March 18, 2024

IDEA Public Schools Electrical Switchgear Upgrades at Multiple Campuses CSP#22-ESGU-0424

ADDENDUM NO. 1

SHEET: S2.1

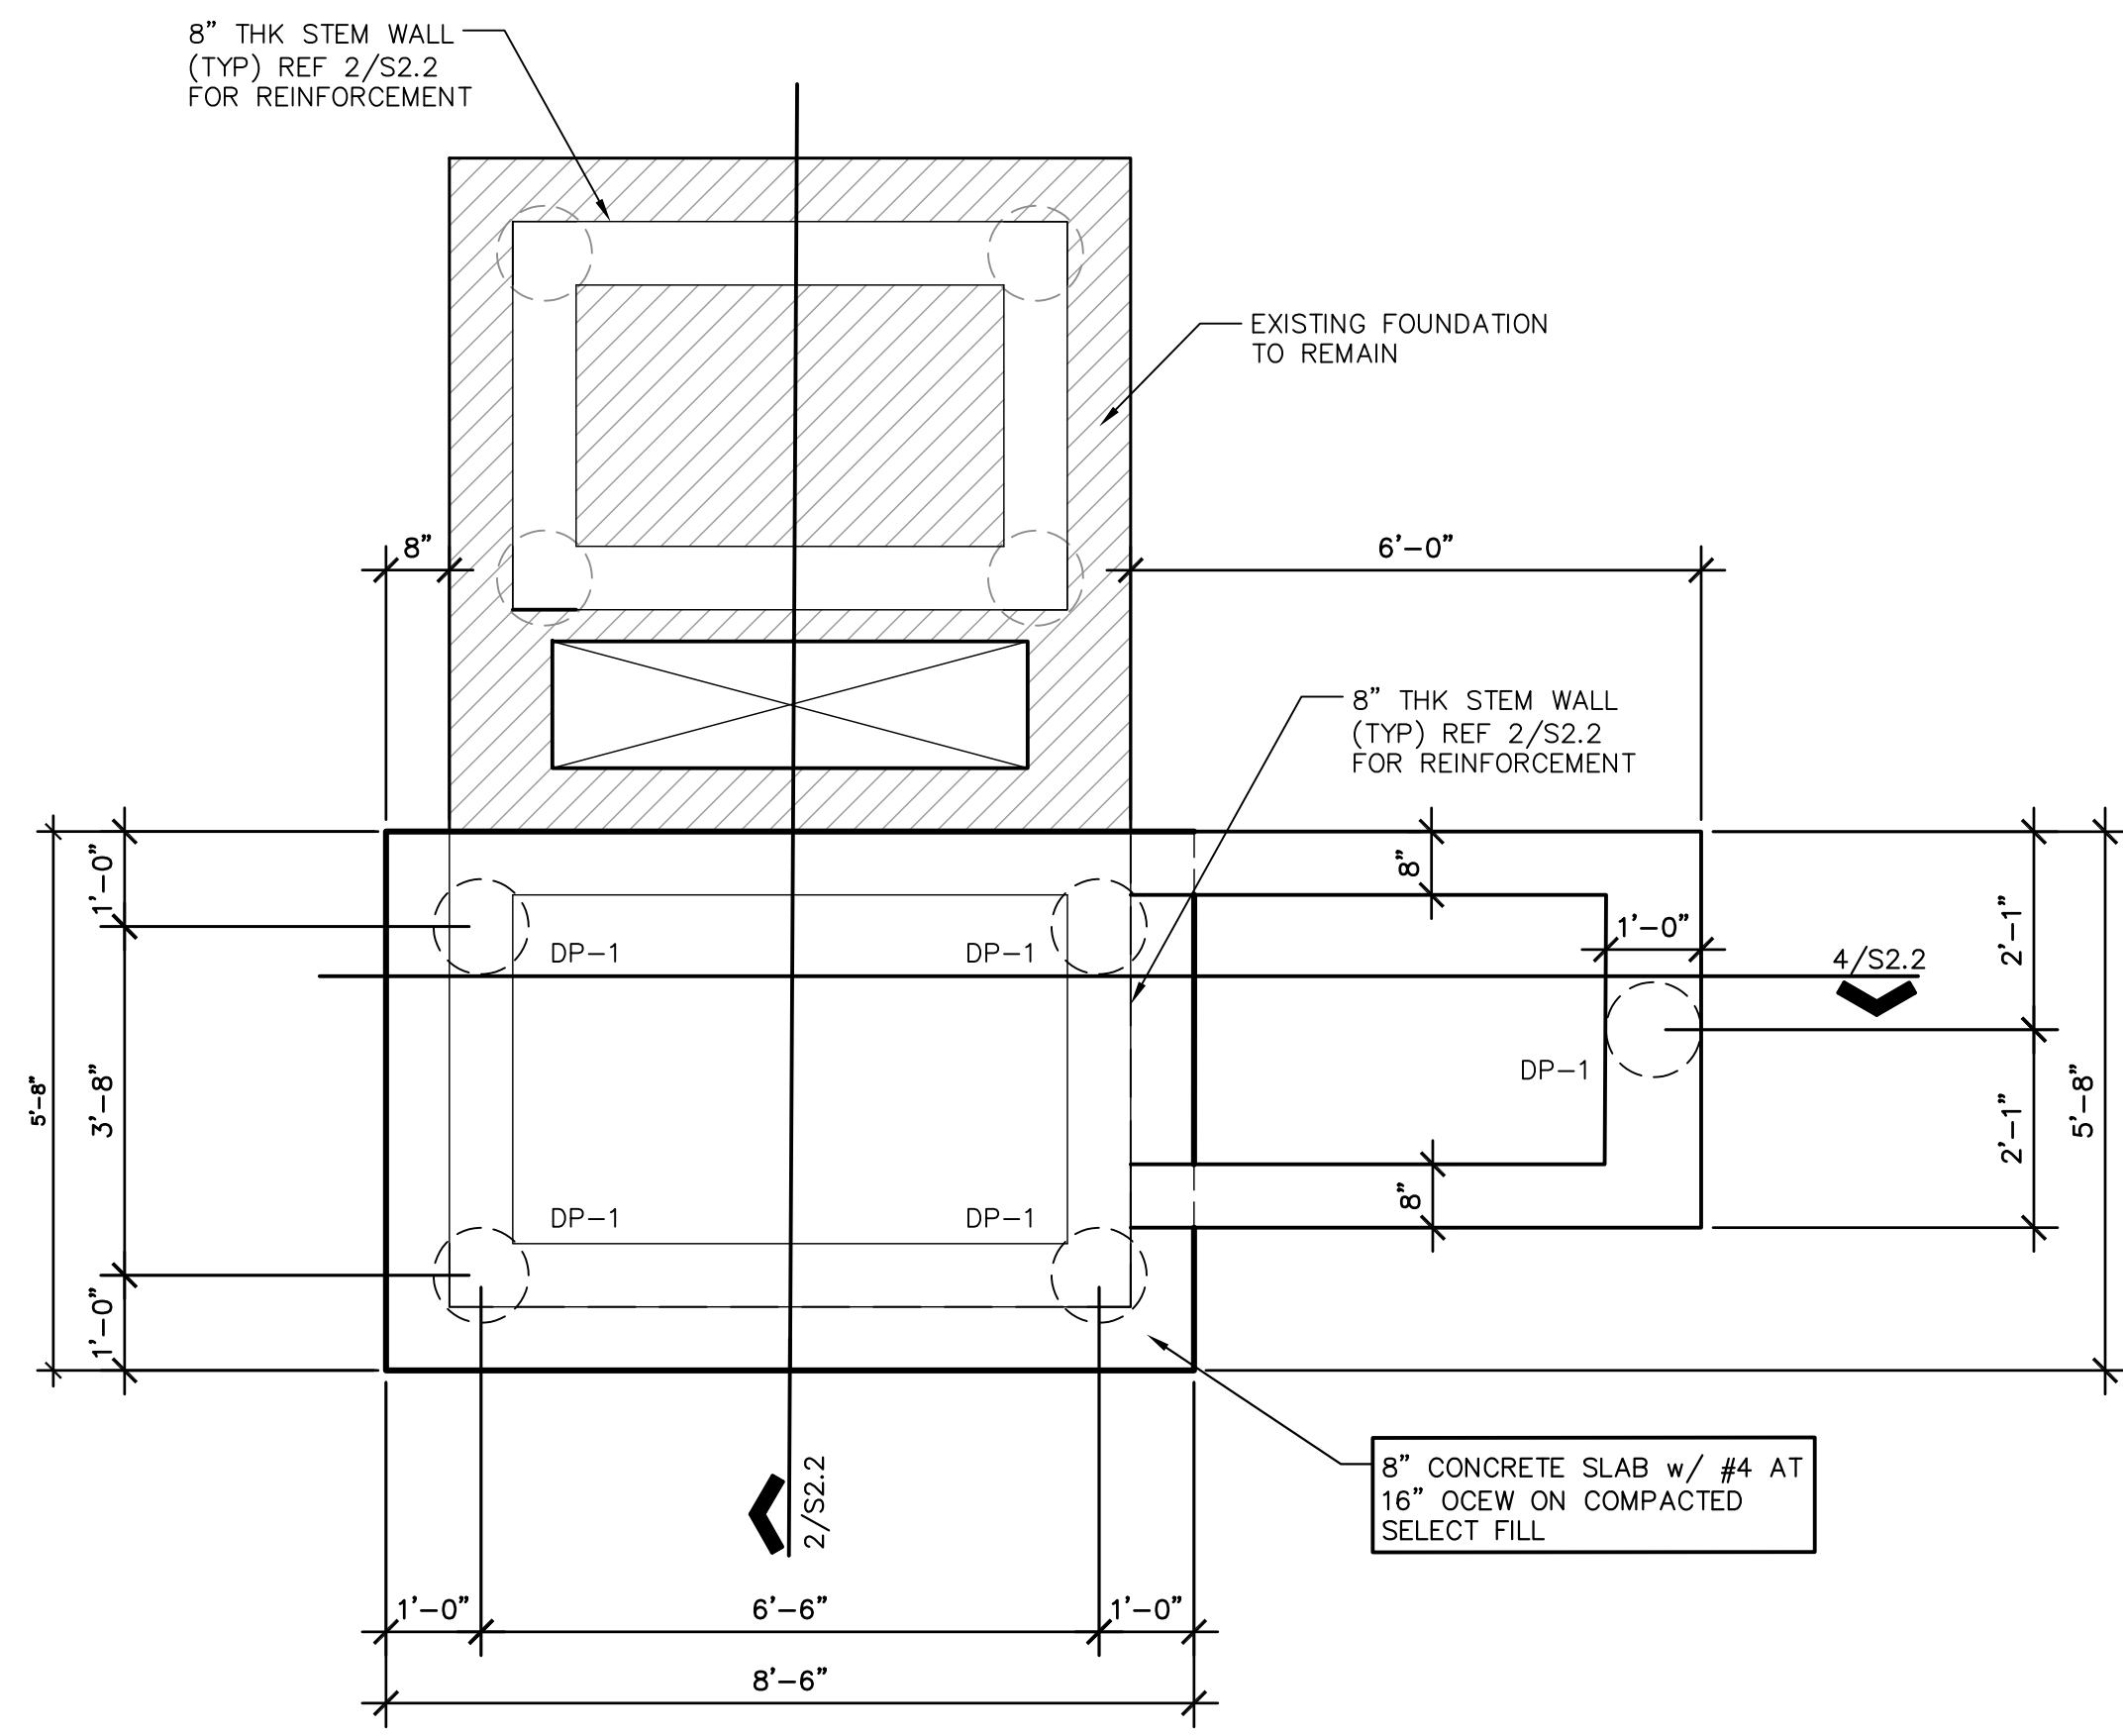
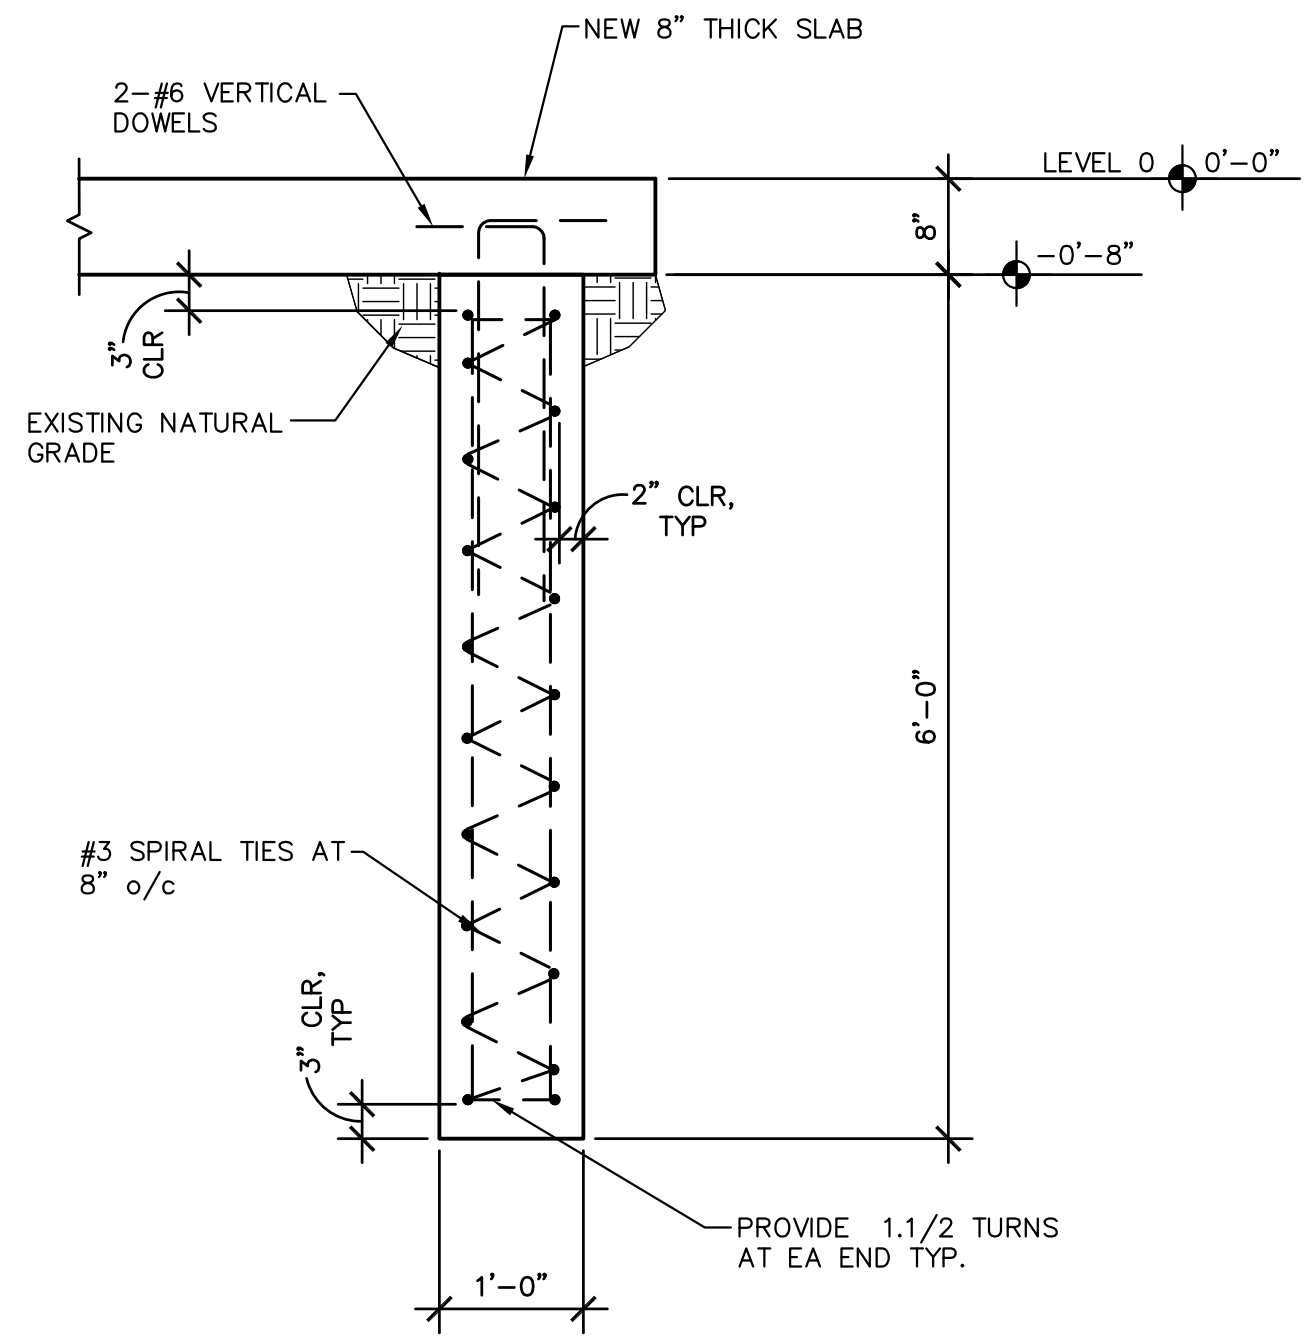
1. Cover:
 - a) Revised Executive Committee, Board of Directors, and Rio Grande Valley Regional Board. See attached sheet.
2. Sheet S1.1:
 - a) Added General Structural Notes. See attached sheet.
3. Sheet S2.1:
 - a) Added Structural Foundation Plan and Drilled Pier Profile. See attached sheet.
4. Sheet S2.2:
 - a) Added Structural Foundation Plan and Elevations. See attached Sheet.

1 LEVEL 0 FOUNDATION PLAN
 1/2" = 1'-0" REFERENCE ELEVATION

2 DRILLED PIER PROFILE
 3/4" = 1'-0"
